Technical Service Bulletin: TSB150046

New Low Temperature Aftercooling Coolant Hose

This document introduces a new Low Temperature Aftercooling (LTA) coolant hose for two stage QSK60 engines.

Figure 1, New LTA Coolant Hose with New Hose Clamp

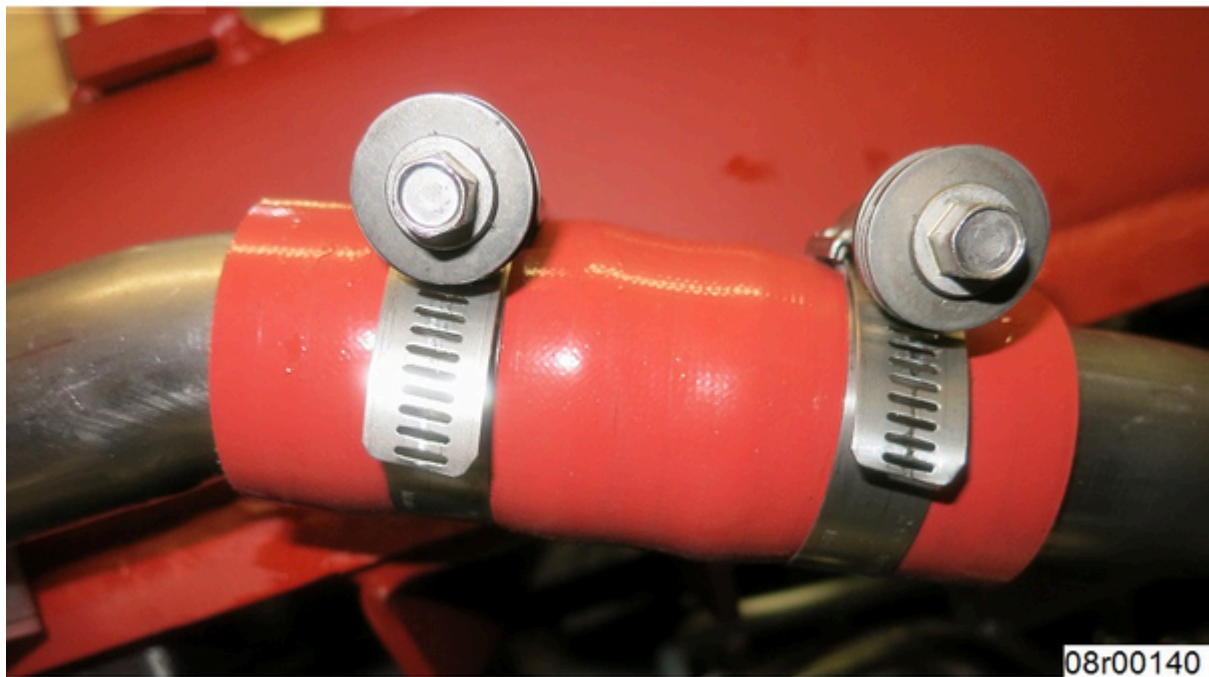
The new LTA coolant hose, Part Number 4381485, has a four ply woven aramid reinforced internal material with a silicon outer wrap.

Hose clamp, Part Number 3922846, **must** be used with the new LTA coolant hose, Part Number 4381485.
